**CITY PLANNING COMMISSION**

**PROPOSAL:** The applicant is requesting the necessary entitlements to subdivide 48+ vacant acres into 223 single family residential lots.

APPLC. NO. P85-139

# VILLAGE PARK UNIT NO. 4

TENTATIVE MAP OF

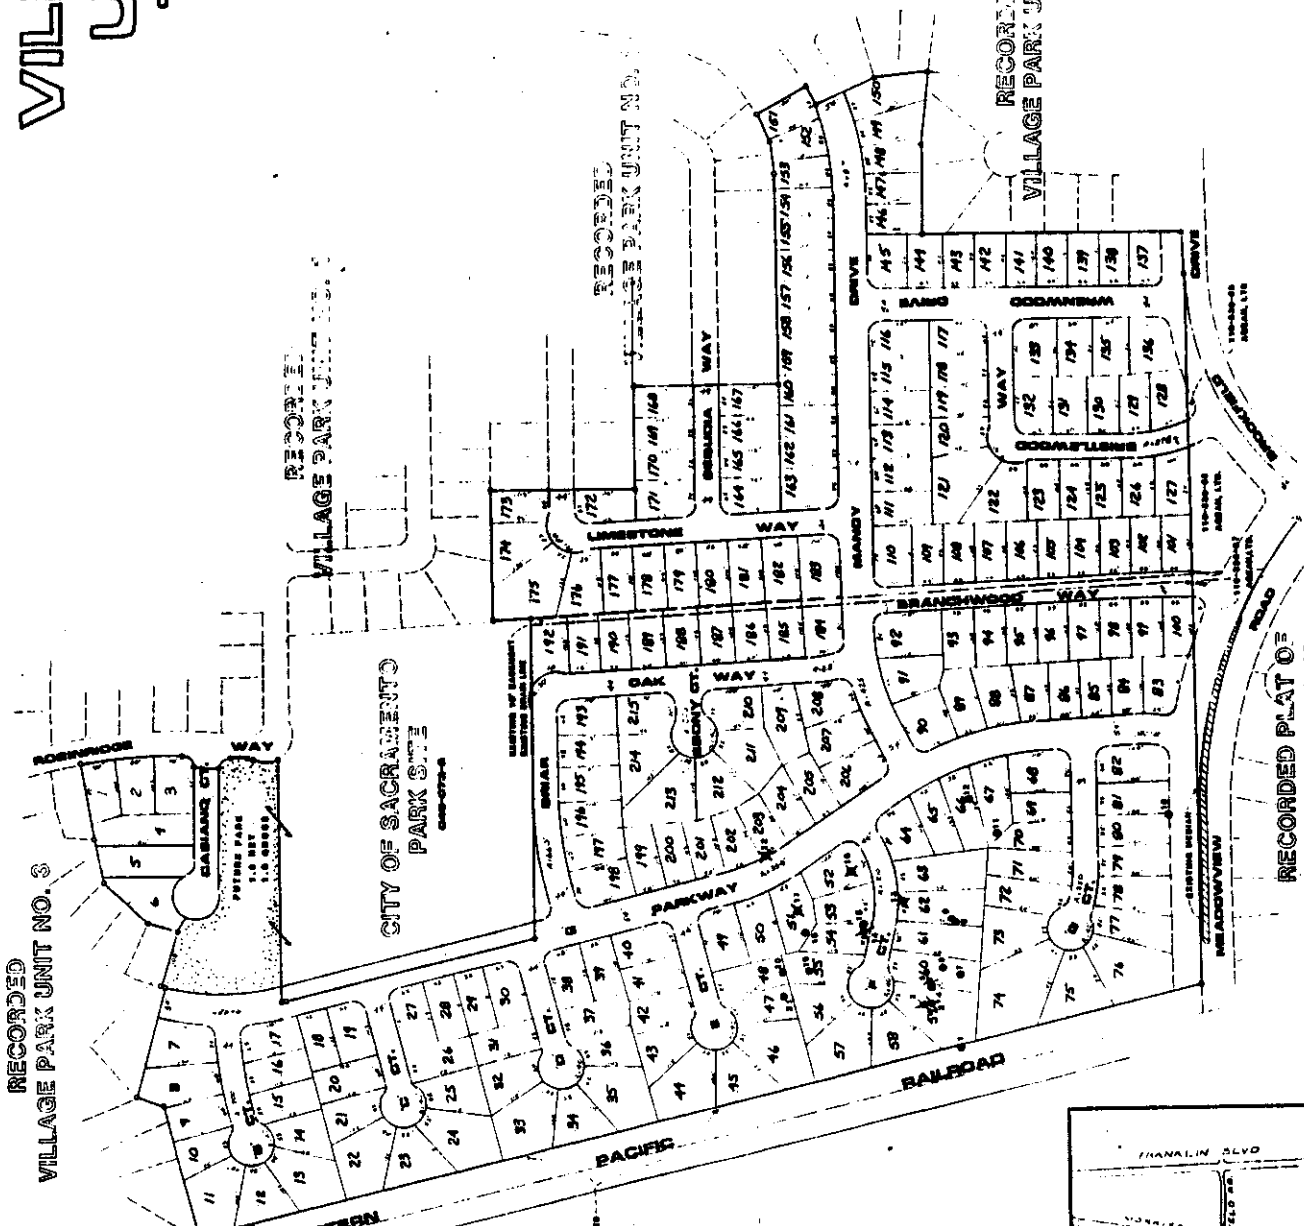
- C. Design: Staff's primary concern with this request is in regard to the seven lots which back onto Meadowview Road. These lots will require buffering for noise and privacy which generally translates into a wall. Staff would not ordinarily support the necessary subdivision modification to create reverse frontage lots. The applicant has pointed out the following design constraints peculiar to the subject site which have caused staff to support this request:

1. There is an existing 10-foot wide drainage easement trending north/south at approximately the center of the site. Utility easements are best located in the center of a street or the rear of a lot. This dictates the location of Branchwood Way;
2. The alignment of G Parkway is dictated by the need for street frontage along park sites and the location of Western Pacific Railroad tracks and the Brookfield/Meadowview intersection;
3. The grade separation between Meadowview Road and the subject site (approx. 4 feet);
4. The Traffic Engineer prefers the reverse frontage lot alternative because people tend to want to pull directly into their driveway from the street.

This design minimizes the number of lots adjacent to the railroad tracks. Financial institutions consider this point important when processing loan packages.

- D. Lots 7 and 71 have side lot lines which exceed 160 feet in depth. Staff supports this subdivision modification request due to the irregular shape of the subject site. These lots should be restricted to single family uses.
- E. The previous approval was conditioned that the applicant construct a sound wall to mitigate noise impacts generated by the railroad tracks. Should a wall be required, a decorative design should be approved by the Planning Director. In addition, the same design and materials of the wall should extend around the seven reverse frontage lots on Meadowview Road. A metal wall will not be acceptable.
- F. The triangular property at the intersection of Meadowview and Brookfield is not owned by the applicant. A proposed future lotting pattern indicates this site can be developed with residential uses (2 lots).

1. Provide standard subdivision improvements pursuant to Section 40.811 of the city Code, including Meadowview and Brookfield.
2. Prepare a sewer and drainage study for the review and approval of the City Engineer.

8. Submit soils test prepared by a registered civil engineer, to be used in street design.
9. Dedicate right-of-way along Meadowview Road and Brookfield Drive as per study on file with the City. Off site dedication will be condemned by the City at the applicant's expense if necessary.

10. Coordinate street improvements of 'G' Parkway and Briar Oak Way adjacent to the City park with Parks and Community Services Division (City Landscape Architect).

11. Grading, trenching, cutting and/or filling within the dripline of those trees designated on the site plan for preservation shall not occur.
12. No actions shall be taken that will harm the health, vitality or longevity of those trees identified on the site plan for preservation.

13. For every on-site tree larger than six inches (circumference at breast height) that is removed, the applicant will replant at the park site a 15-gallon, or larger, Valley Oak or California Sycamore.

14. Submit and comply with the mitigation measures recommended in a County approved accoustical study assessing the proposed project for consistency with the 1974 City General Plan, Noise Element and the 1977 City Noise Control Ordinance.

15. The design of a decorative sound wall shall be subject to review and approval of the Planning Director. Said wall shall be continued behind lots 84-90.

16. The following note shall be placed on the final map: Lots 7 and 71 are restricted to single family development.
